## ENSHAM RESIDUAL VOID STUDY COMMUNITY REFERENCE GROUP MEETING MINUTES

<b>Date</b>	Wednesday 10 <sup>th</sup> October 2018
<b>Meeting Opened</b>	10.02am
<b>Venue</b>	Gateway Conference Room - Emerald

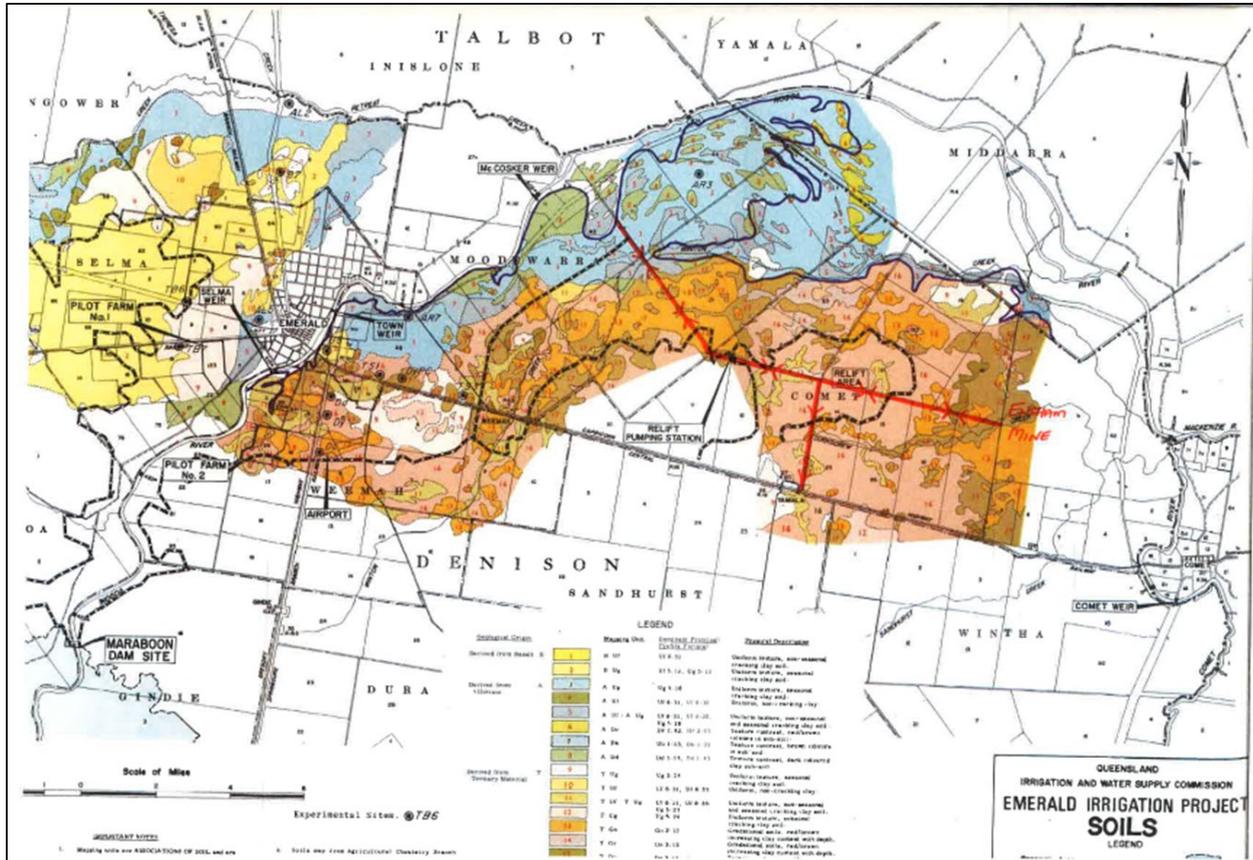
Question	Why is there no releases to the Nogoia?
Response	Once the water quality is proved by running the asset for a period of time, then the operator is within their rights to approach the community and seek approval if there are downstream customers for the water. We can currently discharge under our licensing into the Nogoia, though we will not be using that discharge point for Option 2.

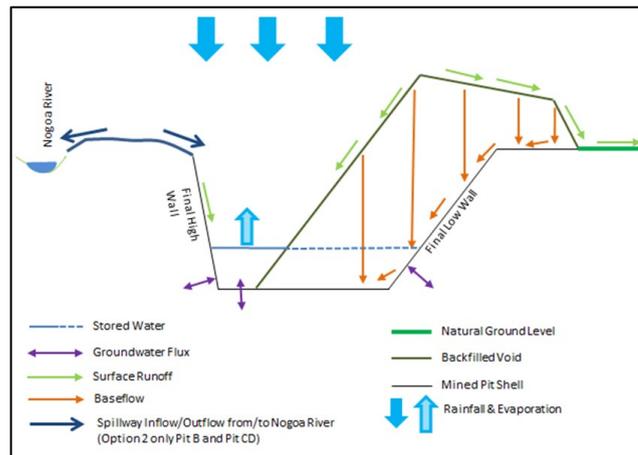
Question	Which reports don't require an IPR?
Response	DY – IQQM, all the rest have IPR. Ecology is still to be Independent Peer Reviewed

- Water quality suitable for irrigation (~ 300 - 800EC)
  - A, B, C and D pits modelled. B Pit modelling below

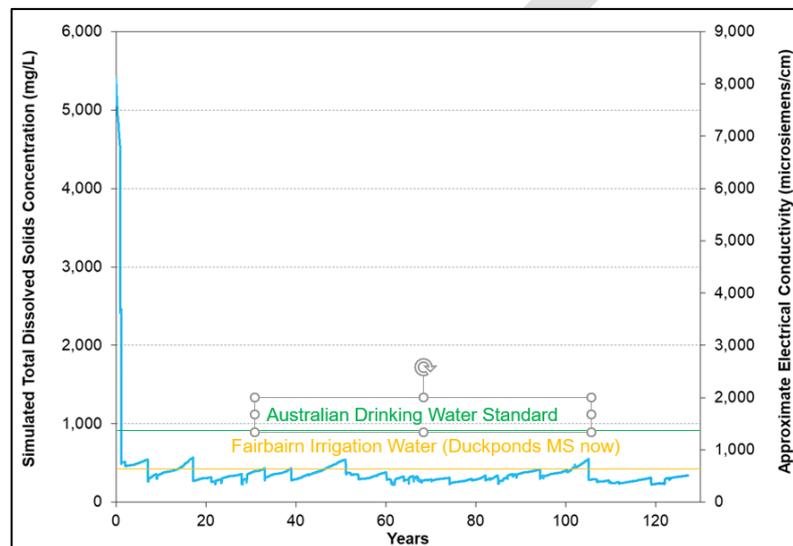
Question	No release to Nogoia, will we cover later the processes related with the increase in salinity below 1000ec, does the dilution relate to the inflow?

Response	DY – correct
Question	In regard to that, as the report is quite confusing, what draw down are you putting into the model to get that? What are you drawing from on a daily basis to put that assumption of ec because your problem comes from draw down and once you start to draw water out of that spoil that's when it come back at you

Response	DN - Owen's modeling is the IQQM stuff that is linked back, the water balance stuff is the site stuff which was all entered into the system.
Question	I still need to get a number in there that told me what the draw down in that assumption was.

Comment	I have been through the report and all the runs and everything are there, though I still have no confidence in that graph to replicate that in the first year you're going to have it at a drop, because once you start to draw down that should not be a straight drop.

Question	Once the pit fills your EC drops down which is great, and you start to draw down. The draw down is critical. Once you draw it down and the level drops as that main water comes out of your spoil and your EC goes up again. That model over that period, what you should see is your salt balance should start pretty high in that spoil and as it draws down it will come in, then after the 2 <sup>nd</sup> or 3 <sup>rd</sup> event it will be less reflective of the draw down. The models not showing that, and I don't know why.

Comment	I don't believe it is correct as you can't end up with an EC out of those pits that is less than the Fairbairn Dam.
Response	DY – I'm not saying in a flood event that the water quality in Ensham will be better than the water quality in the Fairbairn Dam at all. The water quality in terms of EC within the Fairbairn Dam has not been put on the graph. At the moment the orange line represents the water quality that people are using measured at Duckponds monitoring station 2 days ago.

Comment/Question	I was making my comment not based on the graph, it's just looking at all of the model runs. The model runs are still showing historically the water in the pits would be better quality on average than the water at the Fairbairn Dam. The only way that can be driven by would be that you have the very minimal salt loading in the spoil or reduced evaporation because it's a deeper pit and therefore over time during the model runs, but the difficulty is its high priority water you get your pits filled a lot less regularly than the Fairbairn Dam, so the evaporation rate doesn't reduce per ML over a reduced area and salt concentration is very similar to the Fairbairn Dam. I'm struggling with gut feeling over the model runs.

Comment/Question	In the Stage 2 Report it took me a month to figure out why the water quality was as good as what it was. If someone had simply put in to the model with a drawdown of 5ML per day then I would have been able to work out exactly why. In this report we haven't got a drawdown of what's been put into the model. It should be clearly there, so we can see what the assumed daily draw down is in the modelling, so we can understand the interaction of the spoil and how it all works.

Diagram displayed as a snapshot of B Pit. Blue line starts out with the voids at 8000ec with water in them, you then get inflow and it quickly drops down to 1000ec, and based on model inflows over the last 100 years, the blue line roughly indicates what would roughly be the water quality in B Pit. The orange line is currently the water quality in EC at Duckponds monitoring station. The green line is the Australian drinking water standard. Understanding that the Australian drinking water standard has different classes and that you can get quality drinking water below that.

Response	We can give you anything regarding results in that space. I think what you may be talking about is as you draw down the water in the voids the salt is realized from the overburden/ fill materials. This source data was included in the modelling . You can deconstruct all of that with DN but it's a pretty well formed understanding of the project itself and all the detail is in the report

Response	So that will be a specific set of hydrology. What we have is a hundred or so years of hydrology, we have taken historical data, this is a very particular set of climate, flows etc. This represents when the first event is, this is the behavior of what will happen.

Response	PG – I think what this talks about is if we had a small flood event, it may take two or three years.

Response	Another thing is it's a controlled system in that its not a case of we have to start using the water. You will get to see the water quality and how it plays out in reality. It may not drop to that extent initially, though at some point that will happen as it's the nature of that balance.

Response	That's a fair point. We have looked at that issue in quite a bit of detail, we have looked at the historical behavior after the 2008 flood event, so if you look in the Geochemistry Report its actually quite detailed. This data has been used to put in this model.

Response	There are two things that we could give you to provide this information clearer, one is the behavior of the quality as its draining out of the backfill. The other is to show you the water balance behavior within the void.

Response	It's the full balance of inflow, we're comfortable in terms of the ability to supply 20,000ML based on our hydrology and void characteristics and from a quality perspective its about being comfortable with the inflows and outflows of water balance. We're also comfortable with the quality behaviors of each of those individual scenarios and how they play out over time.
ACTION	Hold an additional session to demonstrate more detail within the reports; show behavior flow of the spoil, realistic process, show water balance behavior. Adopt a point around Option 2 Summary to avoid confusion on the graph.
ACTION	Adopt a point around Option 2 summary of the graph, have the volume as well, so you can see what its in relation to.
